Docket Items # 8 & 9  
BAR CASE # 2014-00065 &  
2014-00066

BAR Meeting  
April 2, 2014

**ISSUE:** Request for Partial Demolition and alterations

**LOCATION:** 405 Cameron Street

## French Quarter Light

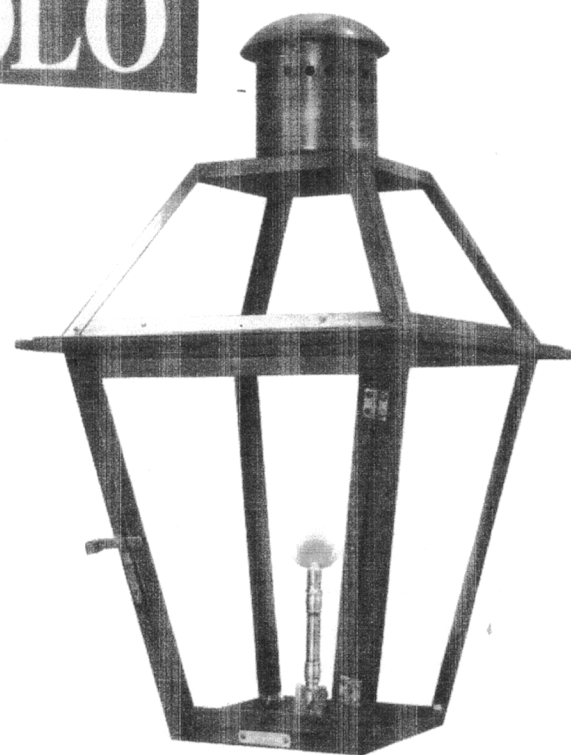
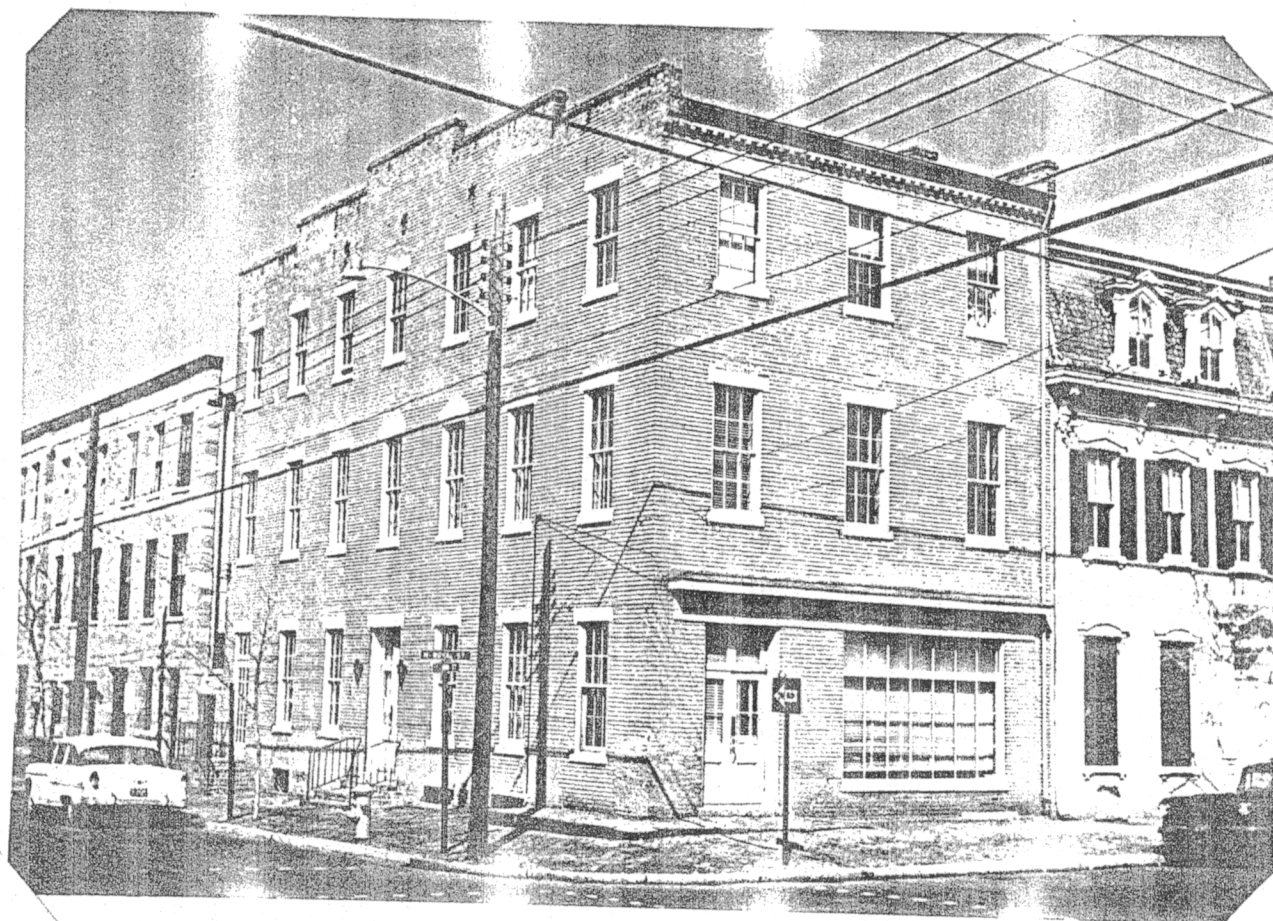
The proposed wood, true-divided light windows comply with the *BAR Window Policy*. The stoop, accessibility ramp, and rail are simple in design and generally meet the criteria of the *Design Guidelines*. While exterior light fixtures do not often appear in period photographs on commercial buildings in 1870, staff suggests that the existing cast iron base and white globe light fixtures may be more appropriate to that period than the Bevolo French Quarter model gas lantern proposed by the applicant. Although a case can be made that this building dates to a transitional period between gas and electrical lights, Staff recommends that the existing globe light fixtures be retained or replaced with a similar period style electric lantern. Staff supports the remainder of the proposed alterations with the condition that the existing granite curb be preserved in situ.

1. The existing granite curb be preserved in situ on the east and south elevation;
2. The rooftop units be painted a light gray color to match the sky; and,
3. The existing globe light fixtures be retained or replaced with a similar style.

EXISTING EXTERIOR SOUTH & EAST ELEVATIONS  
WITH PROPOSED DEMOLITION

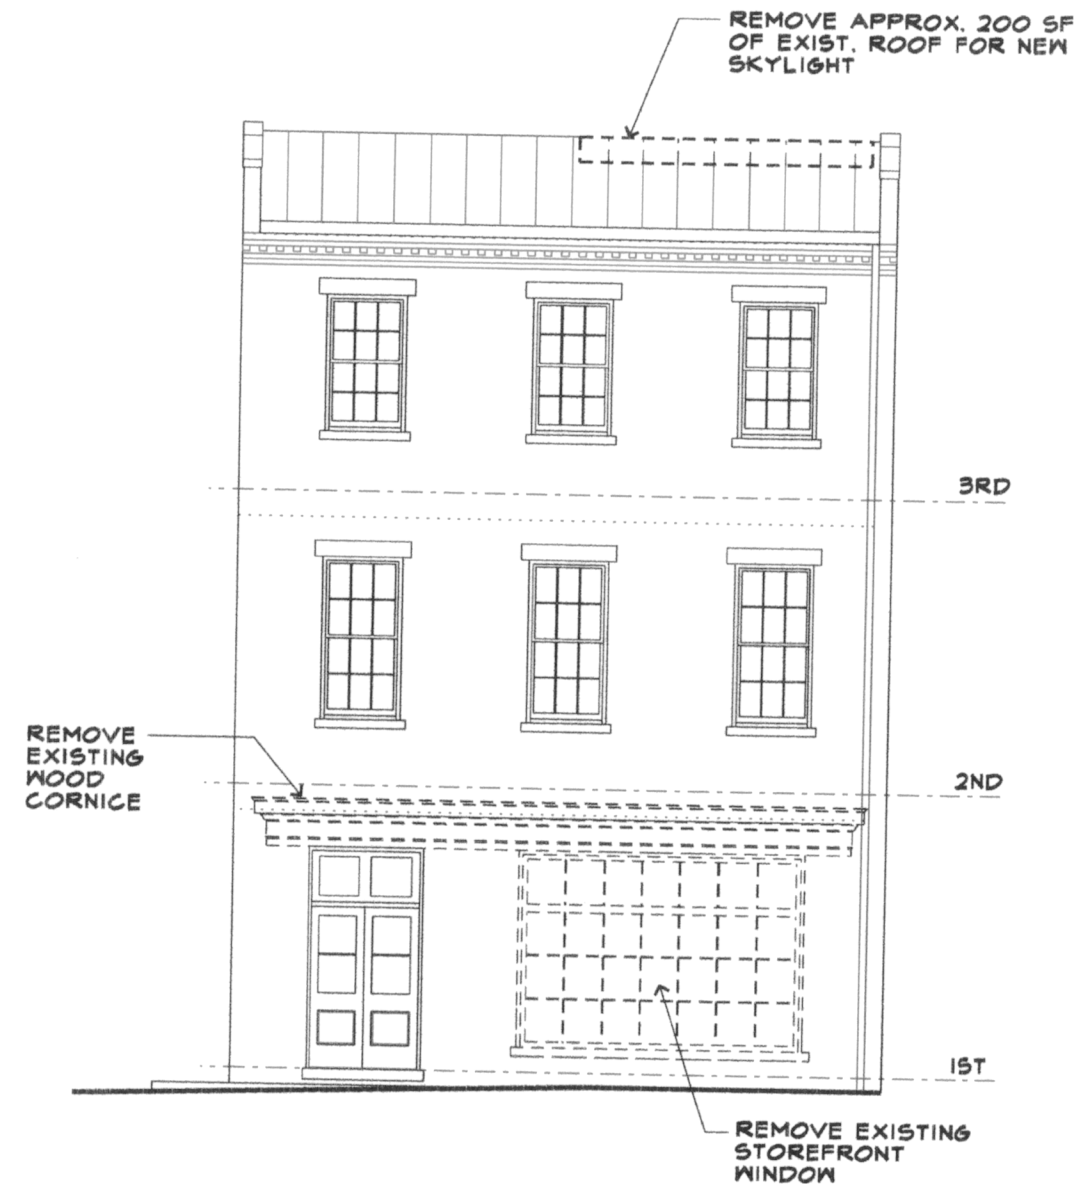
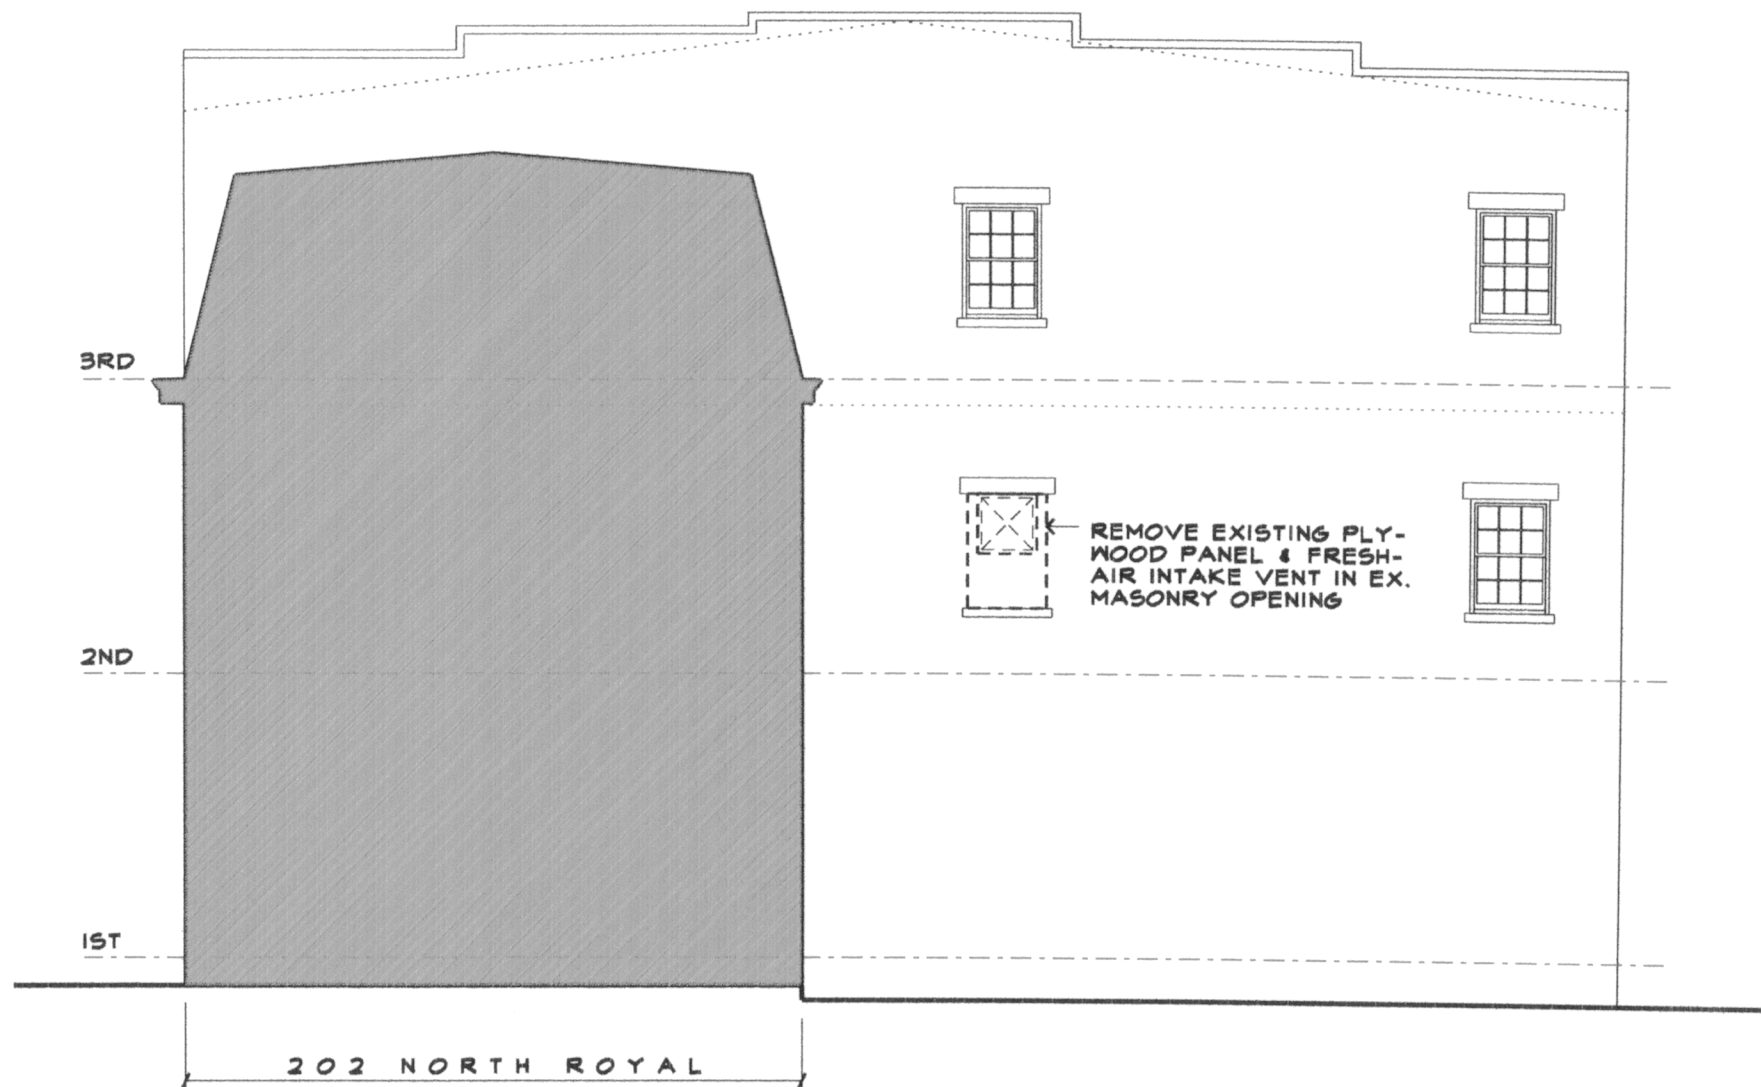
The applicant has worked extensively with staff and provided access to the interior several times, in particular to examine the framing of the storefront window. Staff confirmed on site that there is physical evidence proving the storefront window was a later addition that replaced two smaller window openings that aligned with the windows above. The construction and materials of the storefront window and cornice are of a mid-20<sup>th</sup> century construction. The storefront window was installed prior to March 1959, based on a photograph taken by Russell Jones for Ethelyn Cox's survey. Based on the 1959 photograph, it can also be determined that the globe light fixtures are not original to the building.

The basement windows the applicant proposes to re-open are also clearly visible in the 1959 photograph and based on the symmetry of 19<sup>th</sup> century buildings, these windows most likely existed at the time of its original construction. The steps on the south elevation, facing Cameron Street, are clearly not of historic materials or construction. The existing accessibility ramp on the south side was installed by the City in the mid-1990s. The existing low step/stoop on the east side that wraps around the southeast corner contains a granite curb. While staff has no explanation for the placement of this stoop, and it is possible that the granite was re-used from a street curb or a later alteration, staff recommends that this granite curb be preserved in place as a fully integrated feature of the proposed accessibility ramp, in the event future research confirms its provenance or significance.

All of the proposed demolition, with the exception of the limited area of roof demolition for a new skylight over the interior stairs, will restore the building to its original appearance, which staff supports. Because the skylight will not be visible and will not require demolition of an entire slope or ridge, staff supports its construction.

In general the areas proposed for partial demolition do not meet the above criteria, therefore staff recommends approval of the Permit to Demolish.

PROPOSED EXTERIOR SOUTH & EAST ELEVATIONS

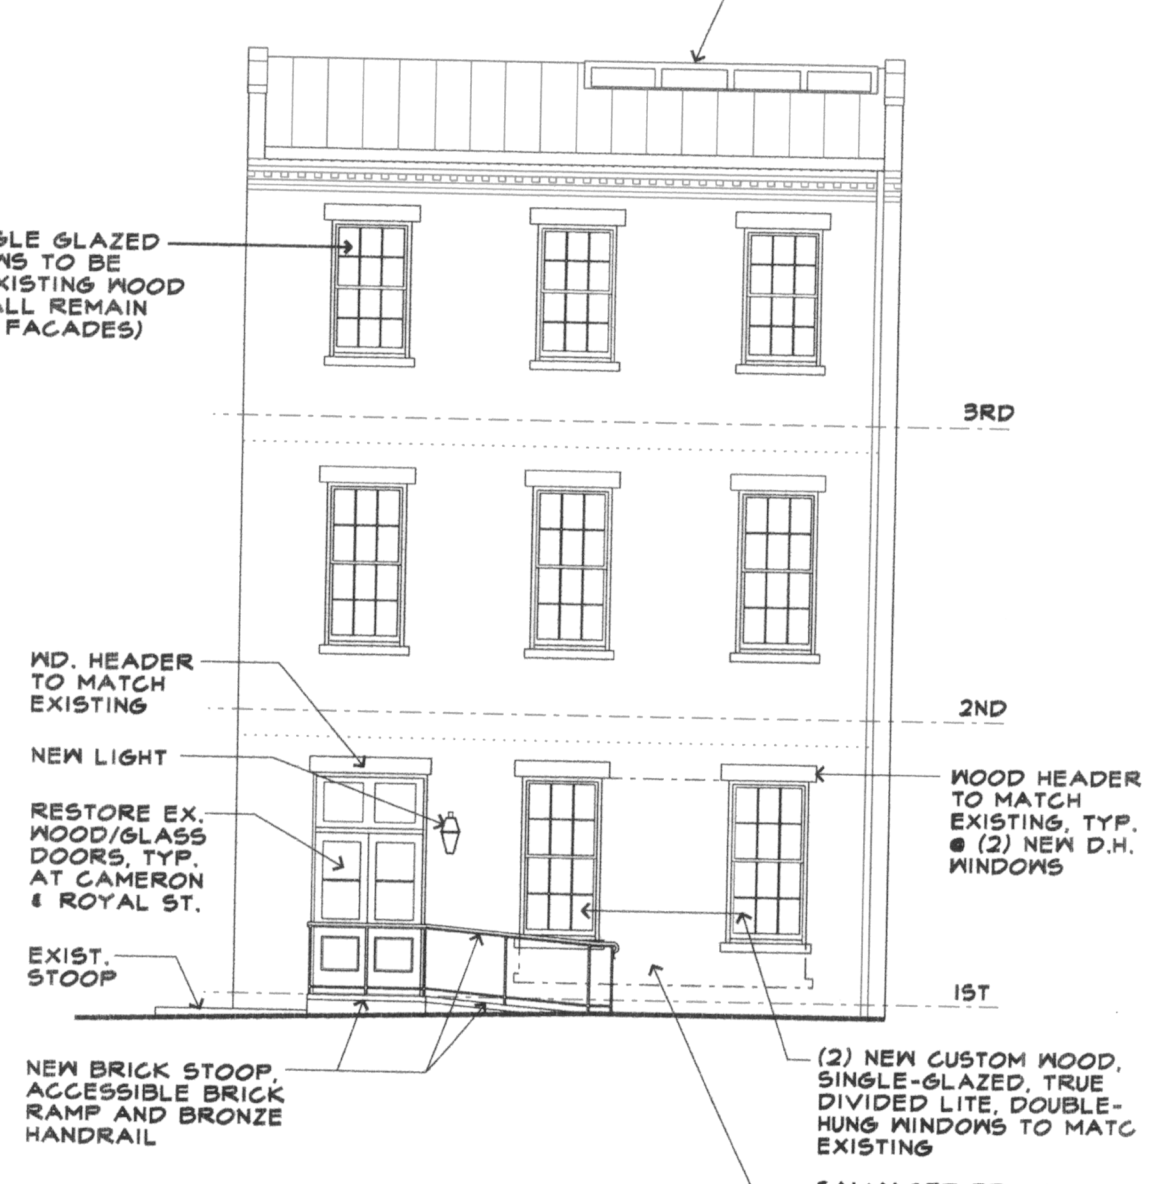
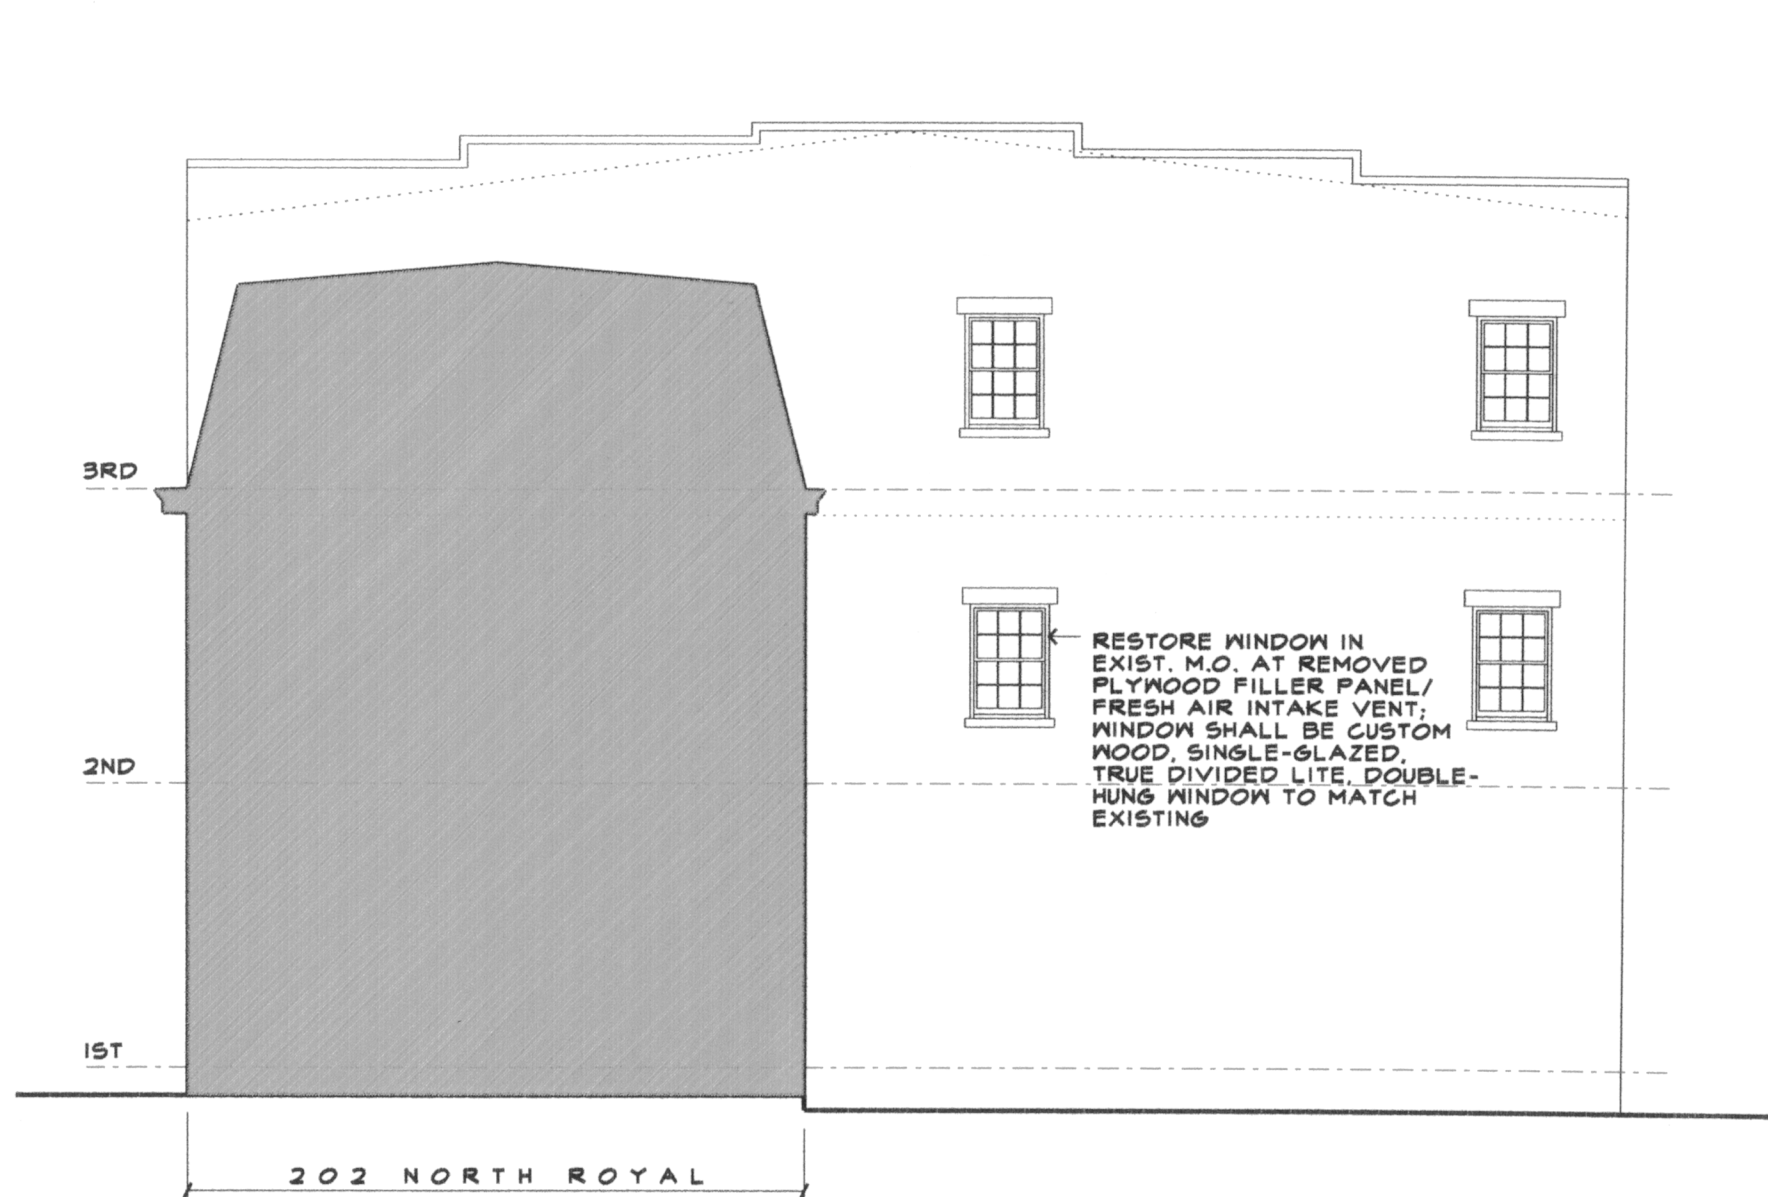
The zoning ordinance requires screening of rooftop mechanical equipment in section 6-403, though the BAR has the authority to grant a waiver of this requirement where the Board determines the screening would be visually more obtrusive than the equipment itself. There are virtually no locations where the proposed mechanical equipment would be visible from a public way. The applicant has shown five small condensers set behind the ridge on the west side of the building behind the existing low parapet. Due to their virtual invisibility from the street and sidewalks, staff finds that screening is not necessary for these rooftop units and supports a Waiver of Rooftop Screening, with the condition that the units be painted a light gray color to match the sky.
